Product Change Notification

PCN20-23-JS Series Slide Switch Base Material Improvement

Figure 1: Older Leadframe Design (left) vs. New Leadframe Design (Right) with stabilizing armature highlighted by green arrows

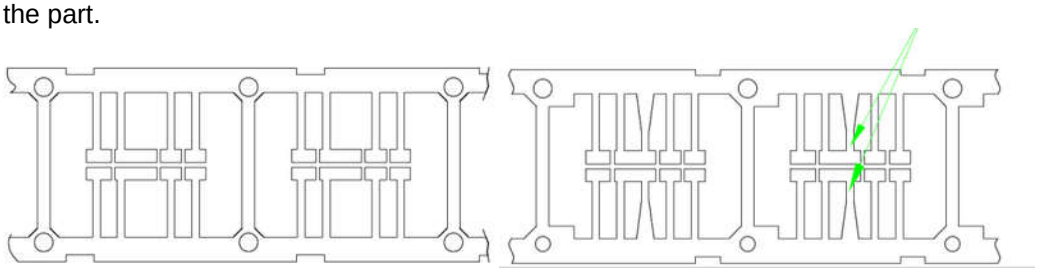
3.2 The underlying leadframe for the parts has been modified to improve overall coplanarity/stability of the part.

Figure 2: Horizontal and Bottom View of Switch w/ Trimmed Leadframe Armature highlighted by red circles

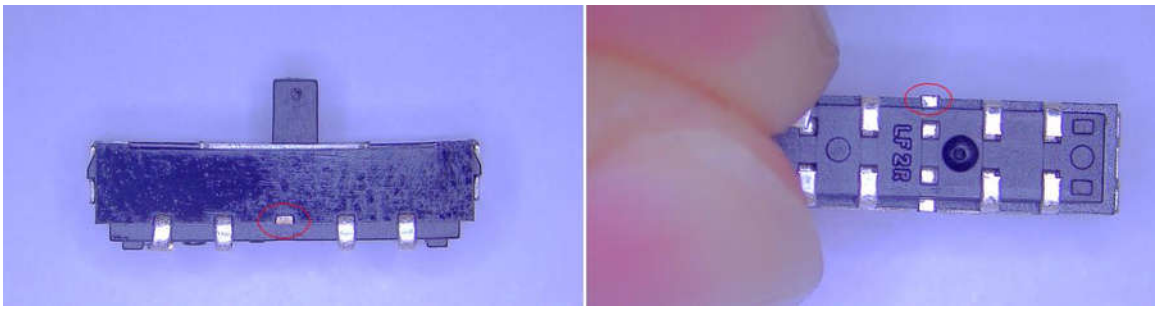
3.3 There is an associated cosmetic change in switch appearance as seen in the pictures below showing a trimmed off additional terminal in the middle of the switch base. This terminal is trimmed off such that it extends no more than 0.3mm outward from the switch base after trimming.
